## ADDENDUM 1

To the Contract Documents for the New Parking Lot

Grand Terrace Elementary School  
Colton Joint Unified School District  
SGH Architects Project Number: 22-12105-04  
DSA A#04-122929

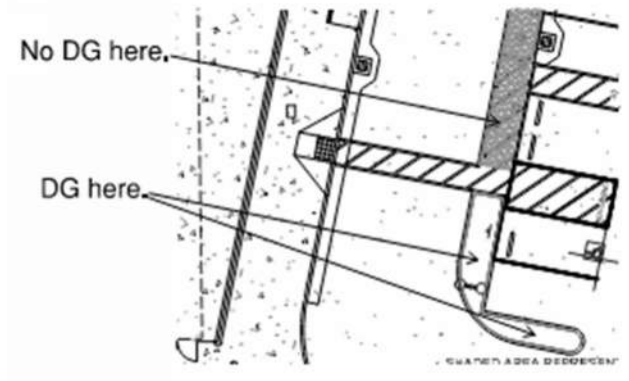
1. Specs 328400/3.02D shows sleeve for mainline is two pipe sizes larger. However, detail Sleeve trenching on sheet L1.02 shows sleeve is 2 times the diameter of pipe or wire. Please clarify.

Response: 2X

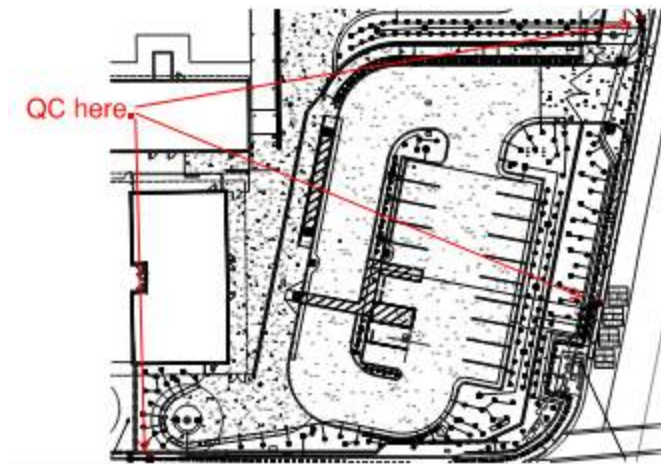
5. Quick coupler valve is shown on irrigation distribution device legend/L1.01. However, it is not shown on plan. Please clarify.

Response: Furnish and install three (3) new Quick Couplers per irrigation Legend at locations noted on this RFI.

PROJECT NUMBER: 22-12105-04  
BIDDING: 04/09/2024  
PROJECT STATUS: DESCRIPTION:  
REVISION: DATE: 06.08.2024  
APPENDIX: 01  
Call 2 Working Days Before You Dig!  
811  
C-2.2

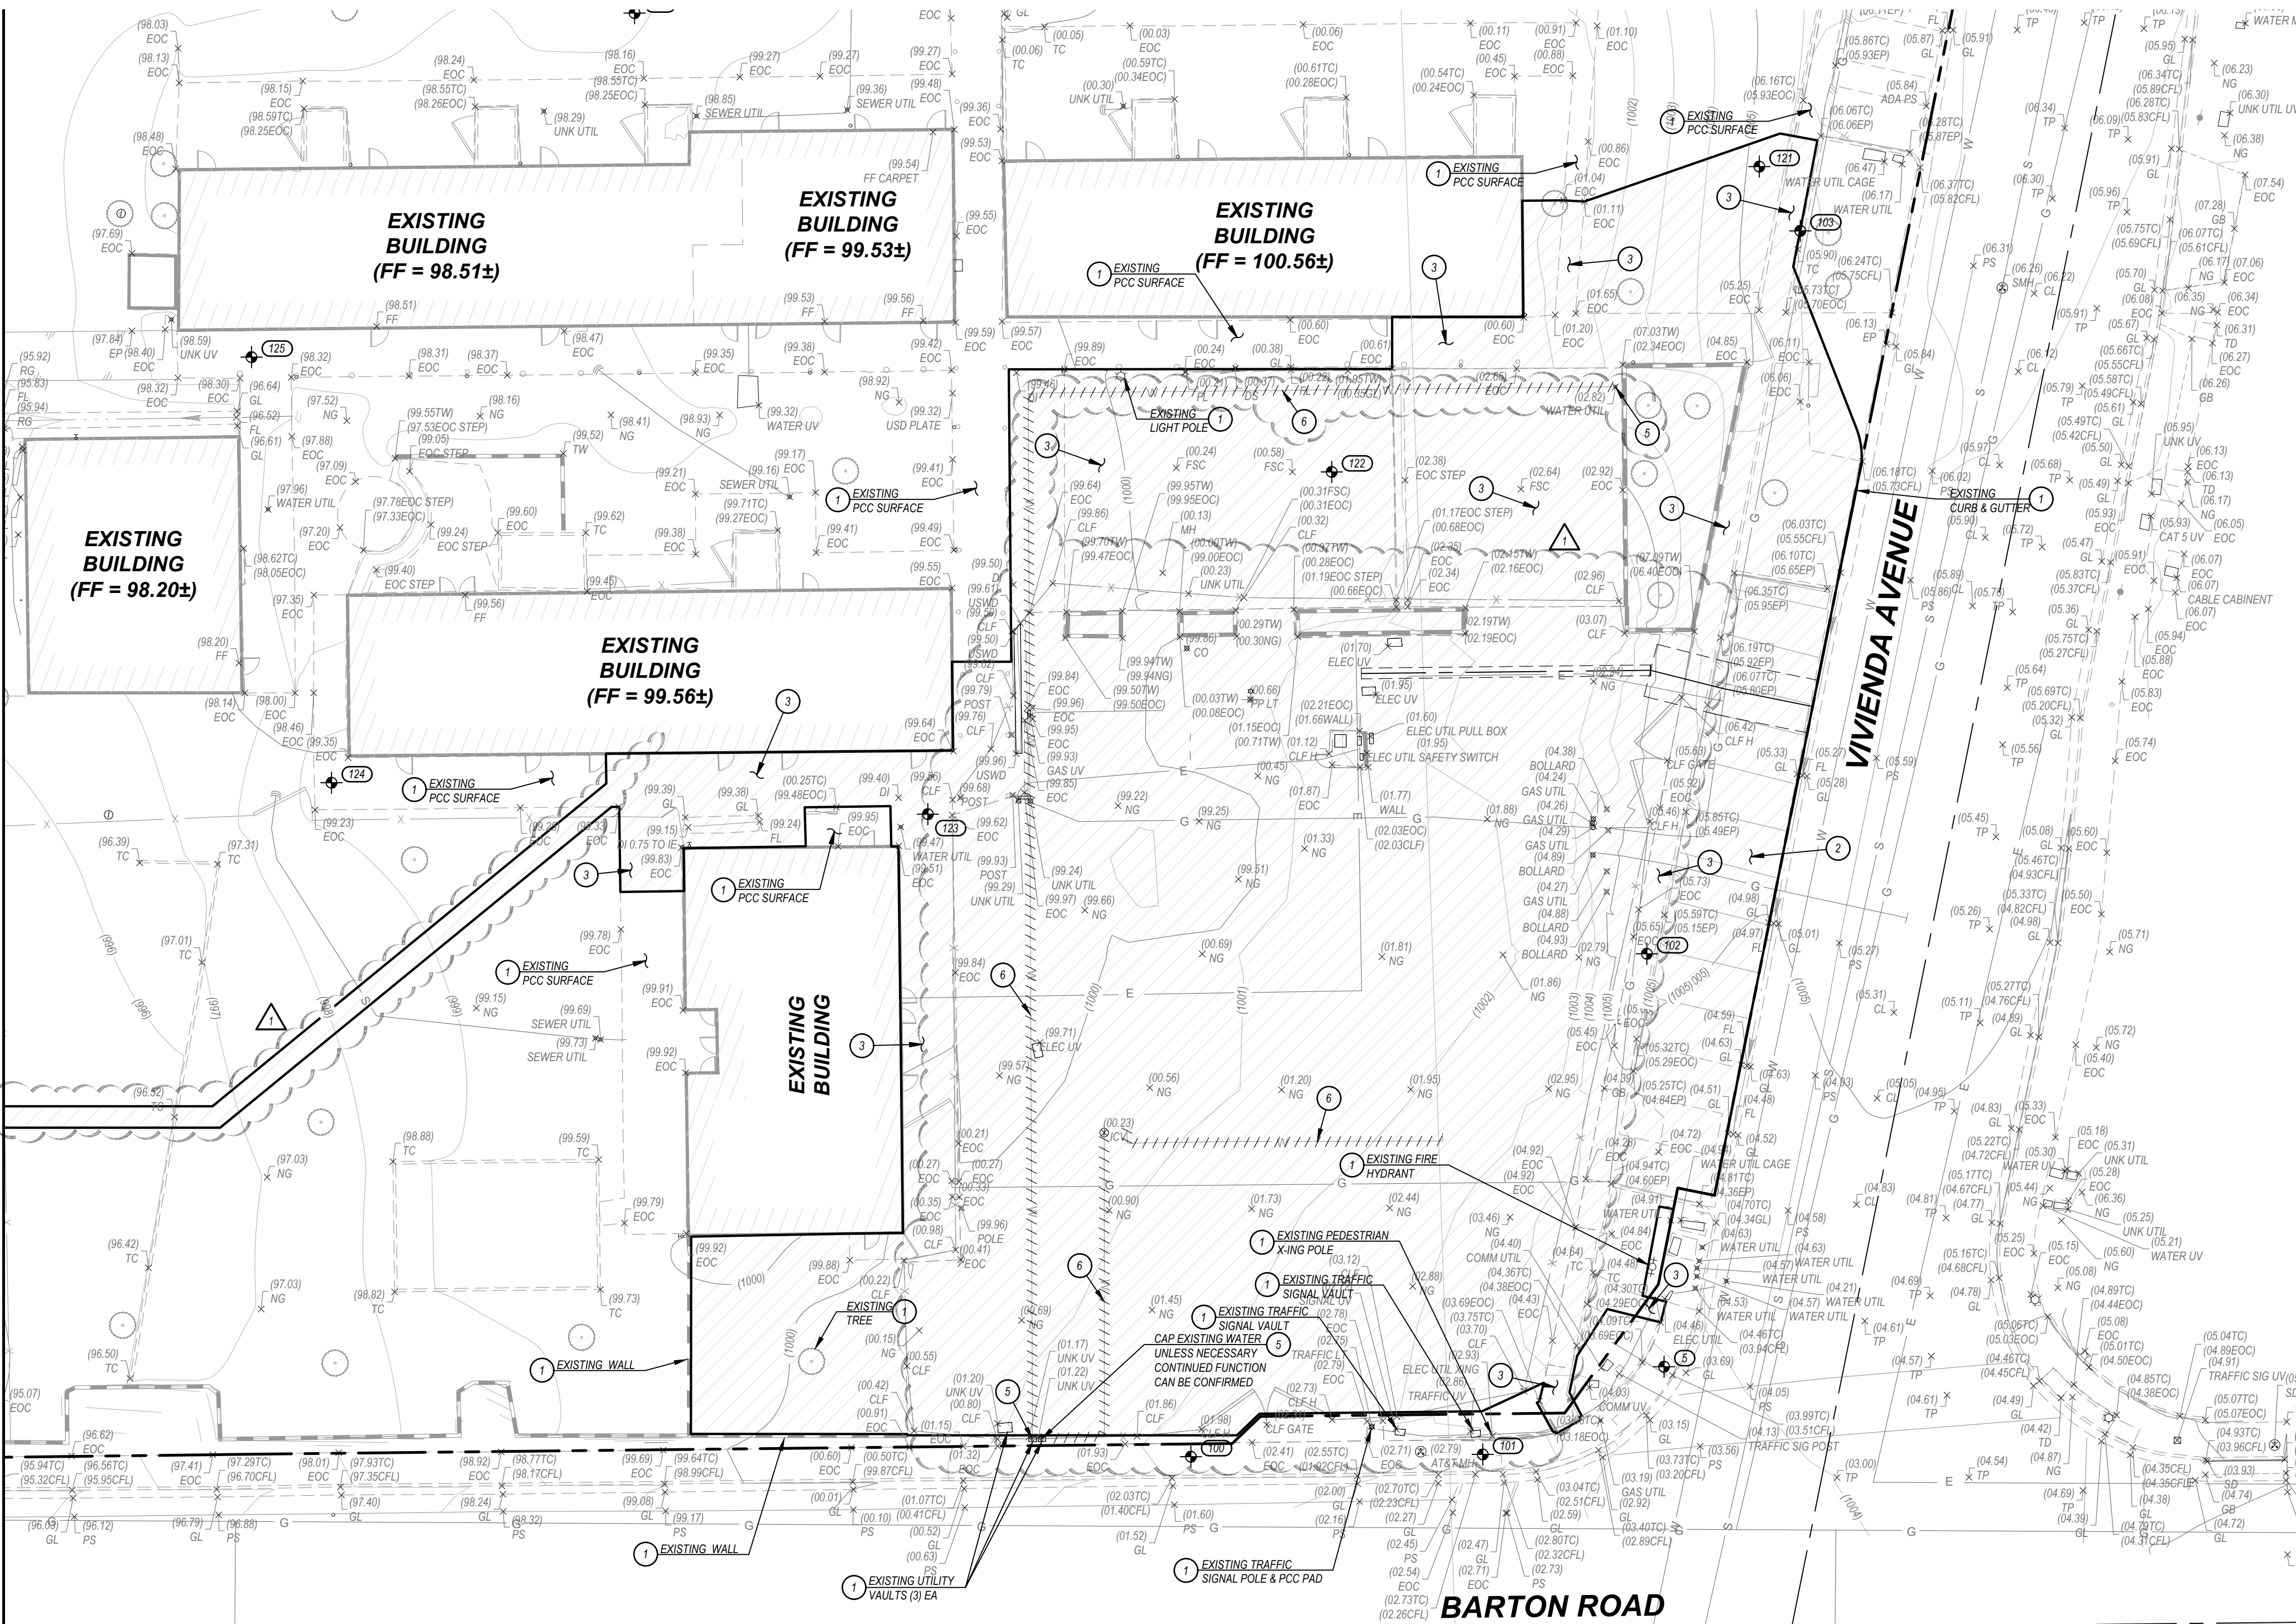
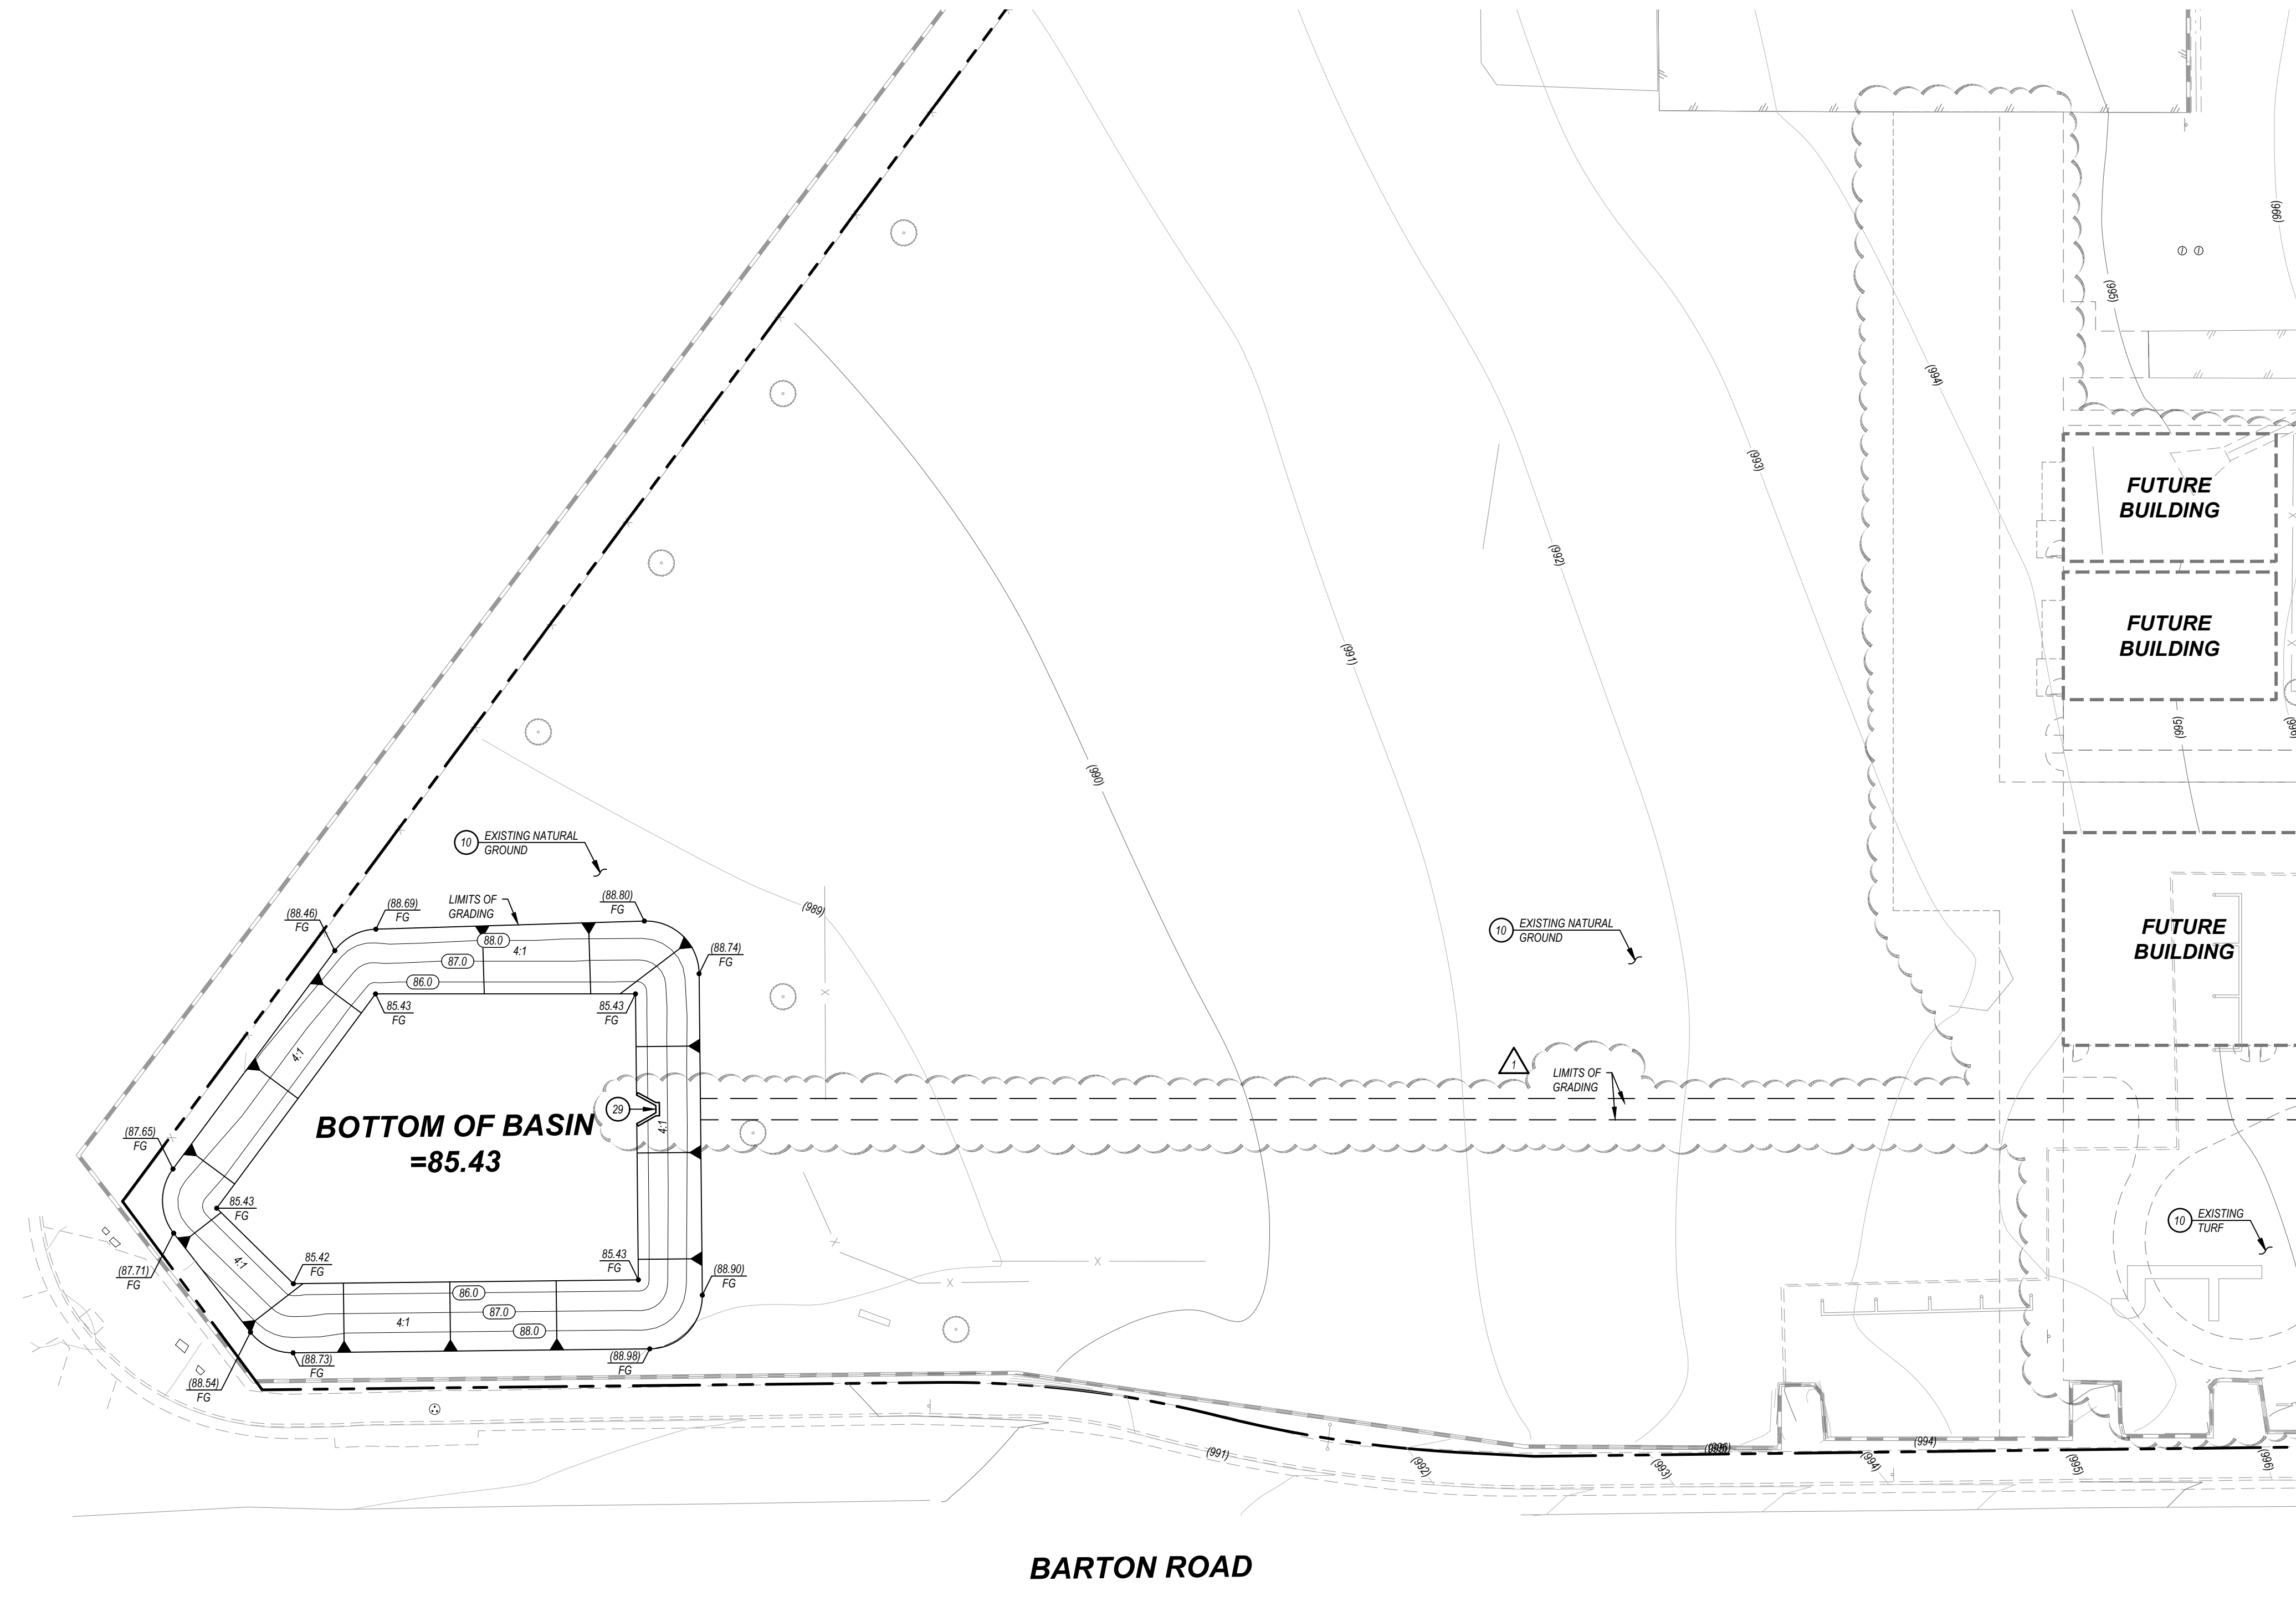
- C. Sheet C-2.2 – Topographic Map  
(Attachment 7)
  - a. Revised alignment of limits of removal due to storm drain revisions.
  - b. Included water line to be removed.
  - c. Adjusted demolition limits of water lines.
